CCPS RFP # 24-09 – Perryville High School – New Field House Project

ADDENDUM #2

This addendum is to answer questions asked during the question period which ended November 30, 2023. Proposers and related parties will be responsible to have read and understand all documents, the scope of work, addenda and all related solicitation documents issued. These documents will become attached to and part of the solicitation and award of bid contract.

1 WALL SECTION 1
A5 3/4" = 1'-0"

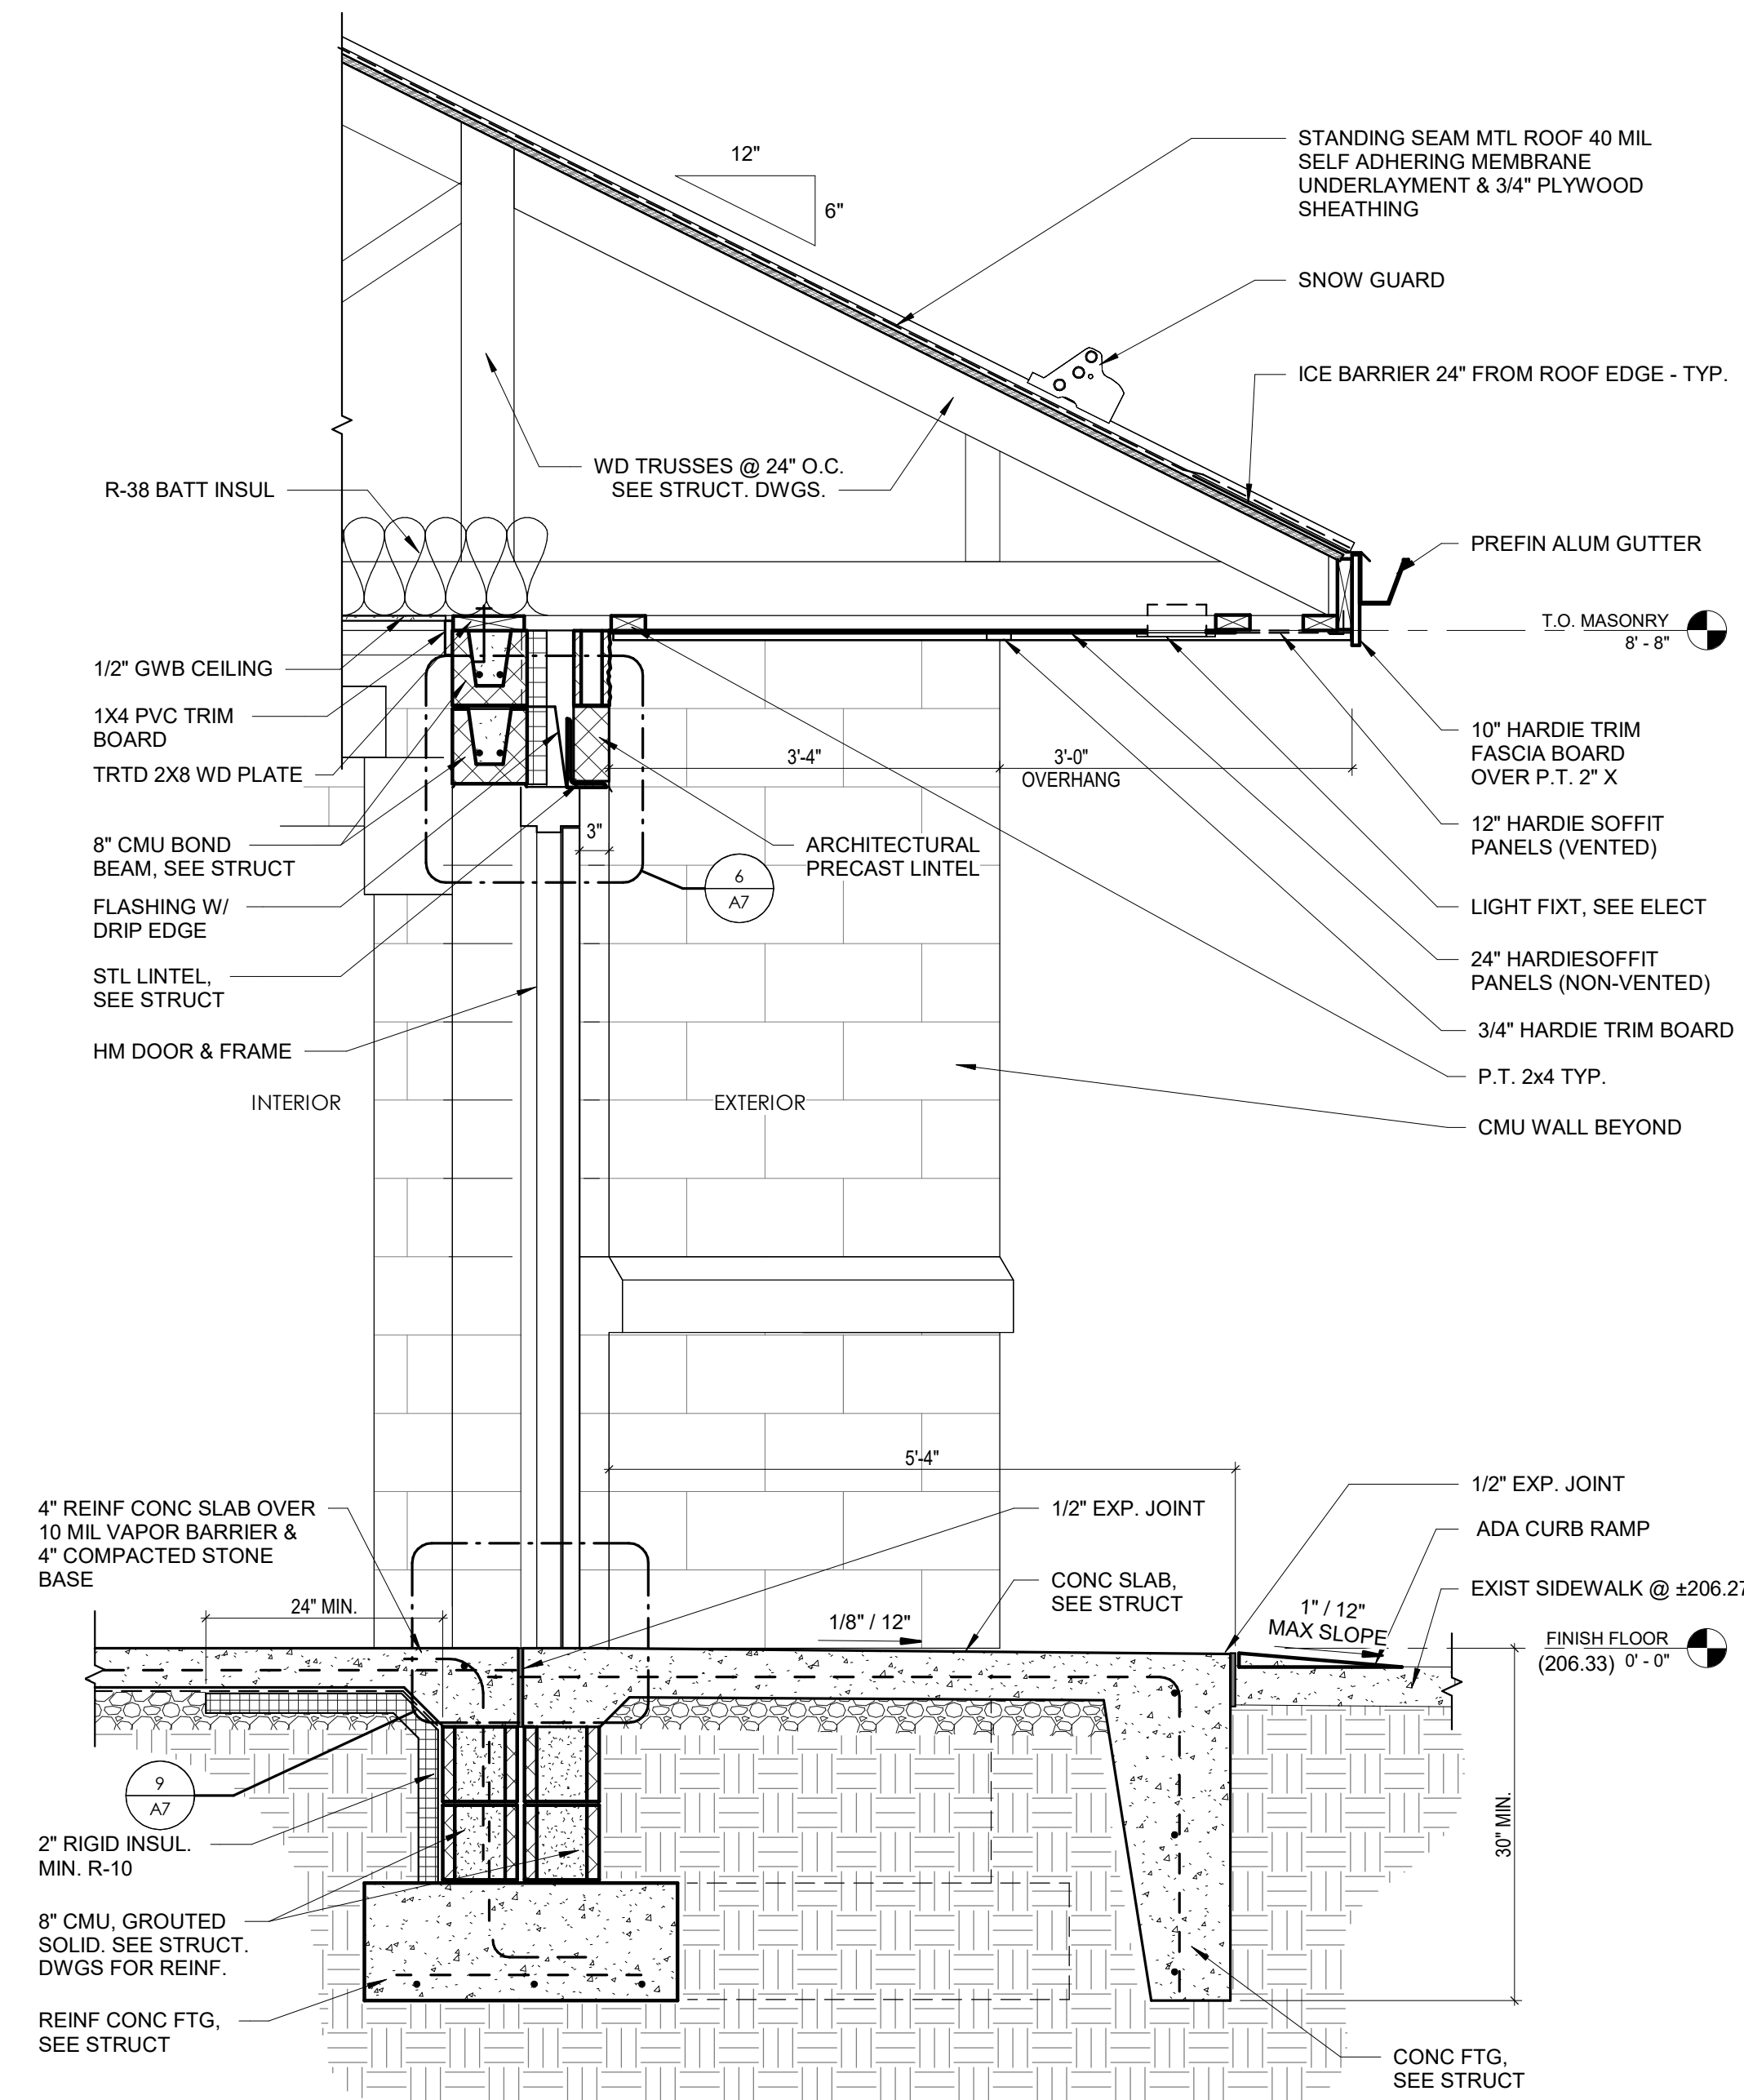
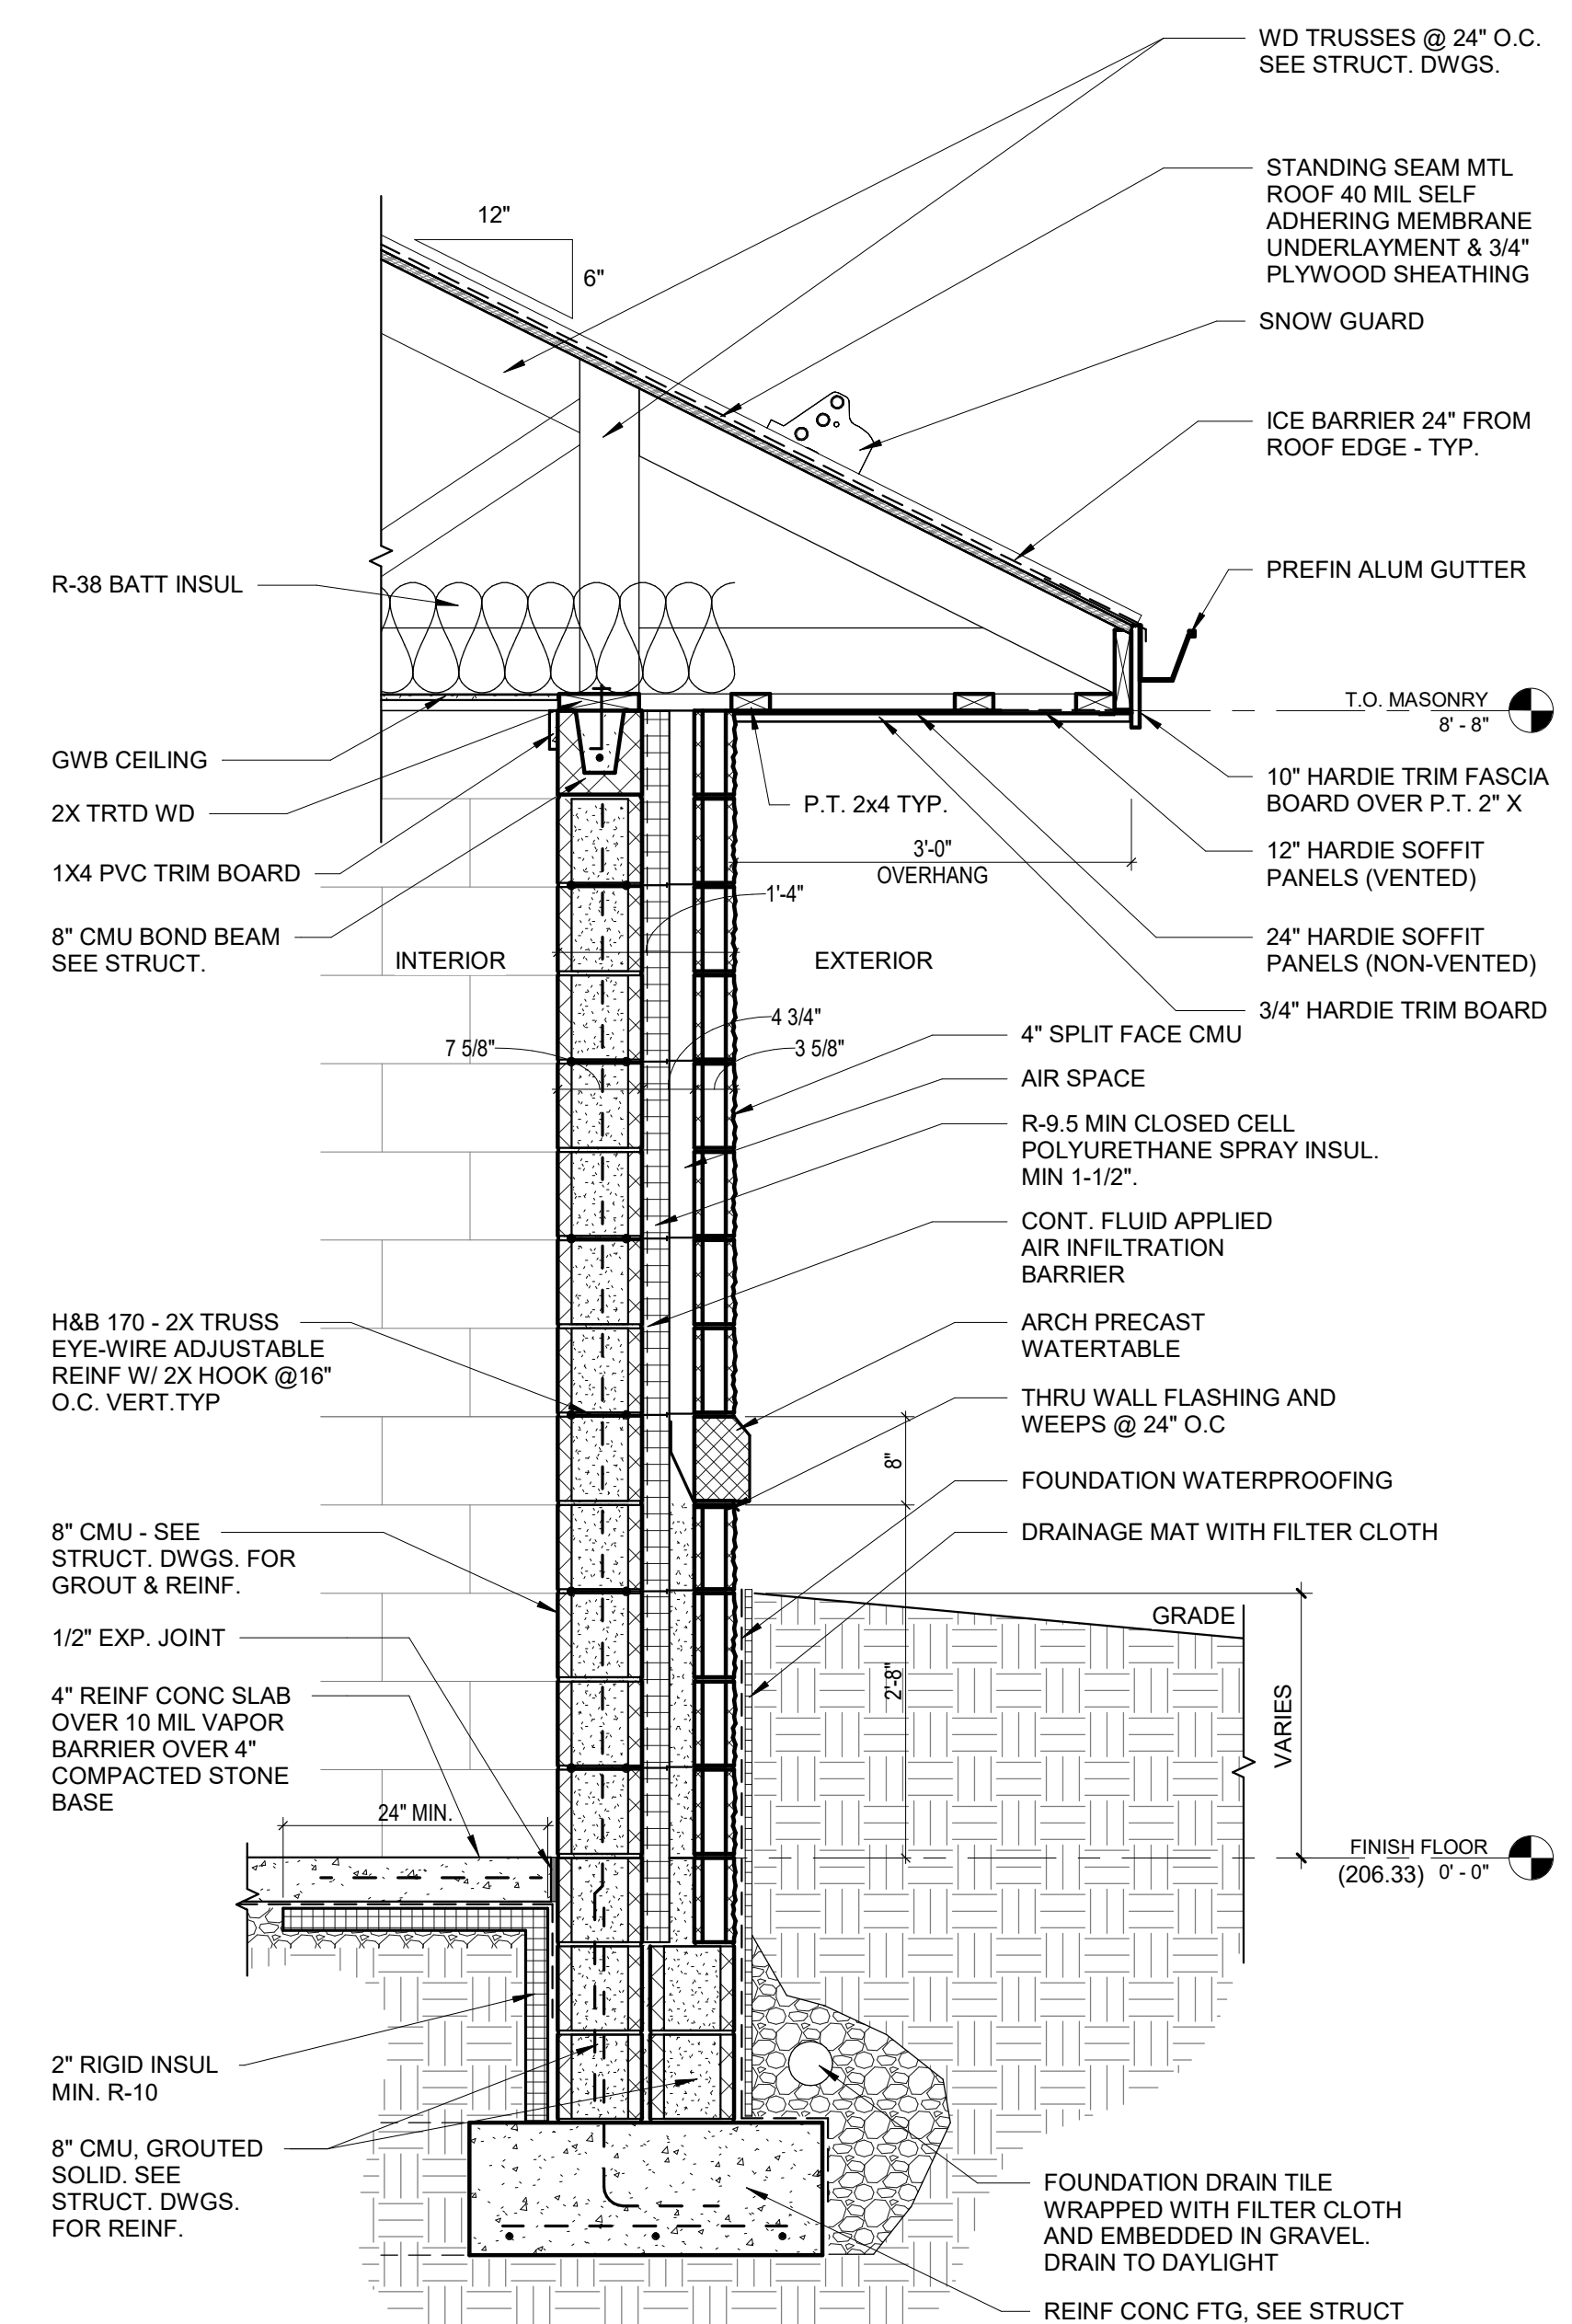
QUESTION 14: On Sections 1 and 3 on A5, spray insulation is called out but it appears to be pointing to rigid insulation. Please clarify which insulation is required.

QUESTION 24: Please clarify the extent of the interior 1x4 PVC Trim Board shown on A5 Wall sections only. Plan view would be most helpful.

ANSWER 14: Closed cell spray insulation is the basis of design. Rigid insulation is an acceptable substitution. Contractor to submit product information confirming that rigid board product substitution meets minimum R-9.5 requirement.

ANSWER 24: 1x4 PVC trim to be installed at all wall to ceiling connections where GWB ceiling is to be installed.

1
S4

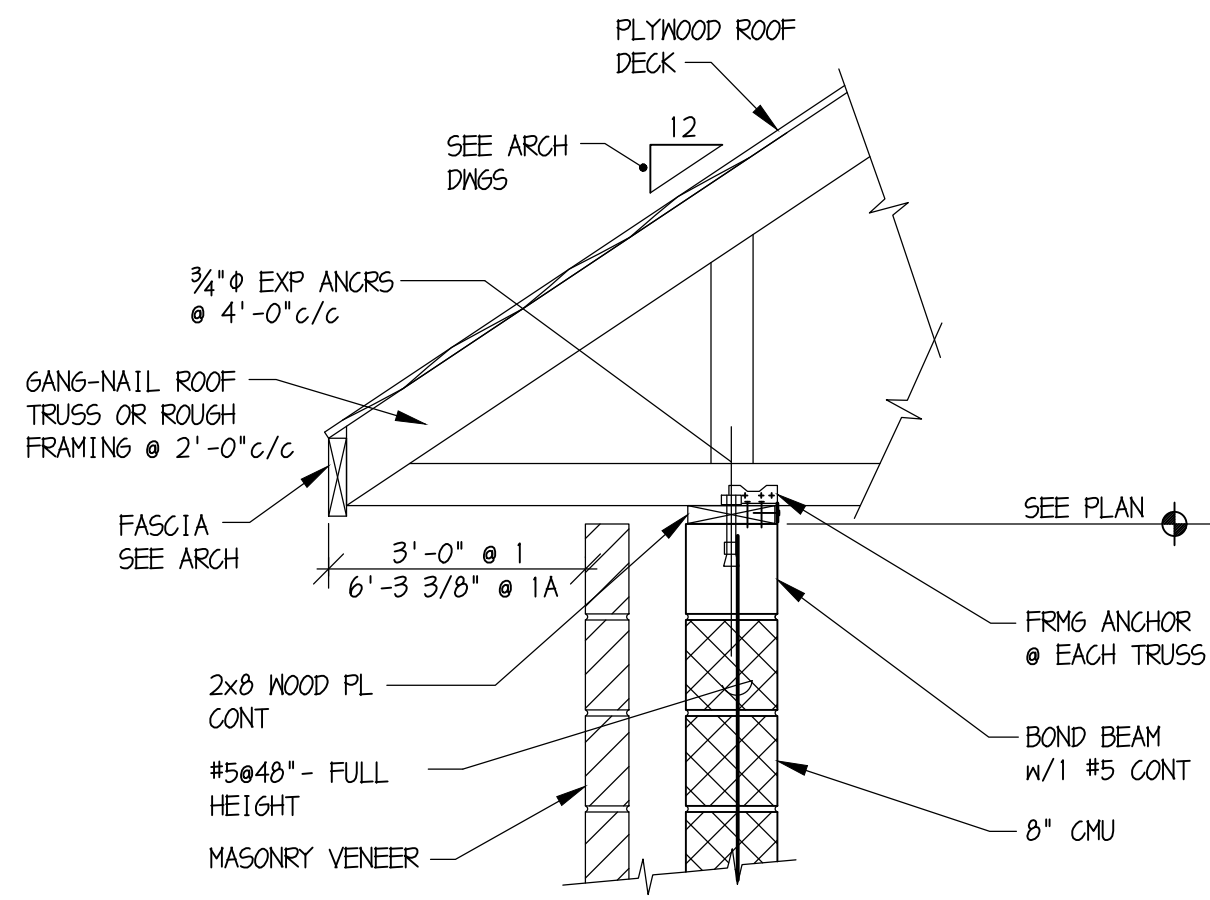
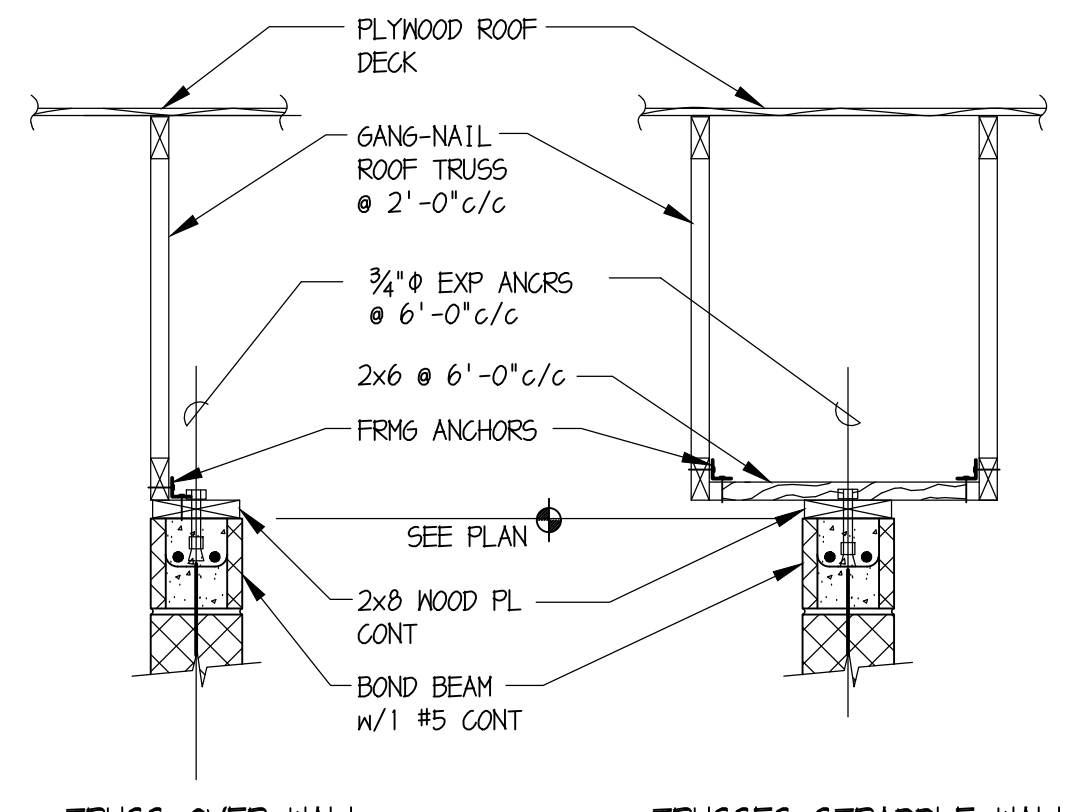
QUESTION 5: On Sheet S4 details 1 and 3, the note states "...w/1 #5 cont" but the drawings show qty 2. Please clarify the quantities of #5 needed for the bond beam application.

ANSWER 5: Provide (2) #5 at each bond beam.
